Access Compliance Report

(Curb Ramps)

Intersection ID: 19463	Main Street: BARCLAY_DOWNS_DR	Cross Street: SAYRE_RD	Location: S
ADA ID: 810568D8E088	Ramp Type: Perp	Initial Pass/Fail: Fail	Overall Compliance: No
Severity Score: 10			
Codes/Mitigation Info/Possible Solution		Field Measurements/Component Compliance

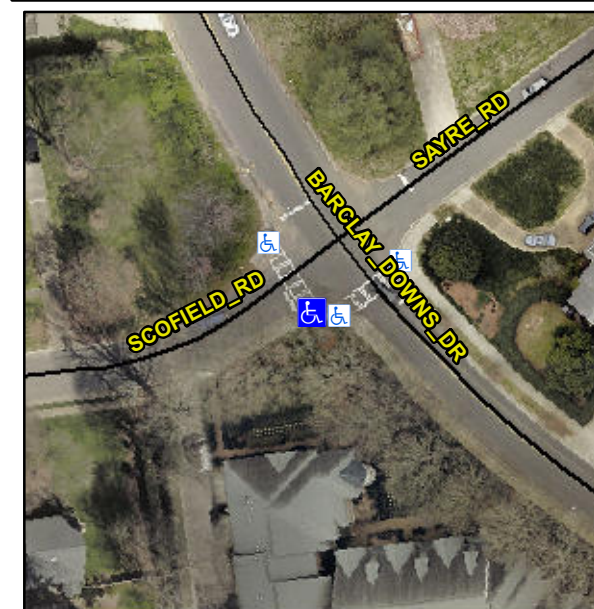
Possible Solutions:

Remove & Replace Entire Ramp.

R304.5.1, R304.5.3

Compliance	Description	Data	Compliance	Description	Data
N/A	Ramp Length (in)	73.0	Yes	Ramp Slope (%)	5.9
No	Ramp Width (in)	38.0	No	Ramp XSlope (%)	4.6
N/A	Flare Type LT	N/A	N/A	Flare Type RT	N/A
N/A	Flare Slope LT (%)	N/A	N/A	Flare Slope RT (%)	N/A
N/A	Flare Traversable LT?	N/A	N/A	Flare Traversable RT?	N/A
N/A	Landing Length (in)	N/A	N/A	DWS Provided?	N/A
N/A	Landing Width (in)	N/A	N/A	DWS Contrast?	N/A
N/A	Landing Slope (%)	N/A	N/A	DWS Length (in)	N/A
N/A	Landing X Slope (%)	N/A	N/A	DWS Full Width?	N/A
N/A	Landing Curb? (Y/N)	N/A	N/A	DWS Offset (in)	N/A
N/A	Shared Landing?	N/A			
N/A	Gutter Ponding?	N/A	N/A	Gutter Slope (%)	N/A
N/A	Gutter Lip Ht (in)	N/A	N/A	Gutter X Slope (%)	N/A
N/A	Painted X Walk1?	Yes	N/A	Painted X Walk2?	N/A
	X Walk 1 Direction	To N		X Walk 2 Direction	N/A
N/A	X Walk 1 Width (in)	94.5	N/A	X Walk 2 Width (in)	N/A
	X Walk 1 Slope (%)	1.4		X Walk 2 Slope (%)	N/A
	X Walk 1 X Slope (%)	4.9		X Walk 2 X Slope (%)	N/A
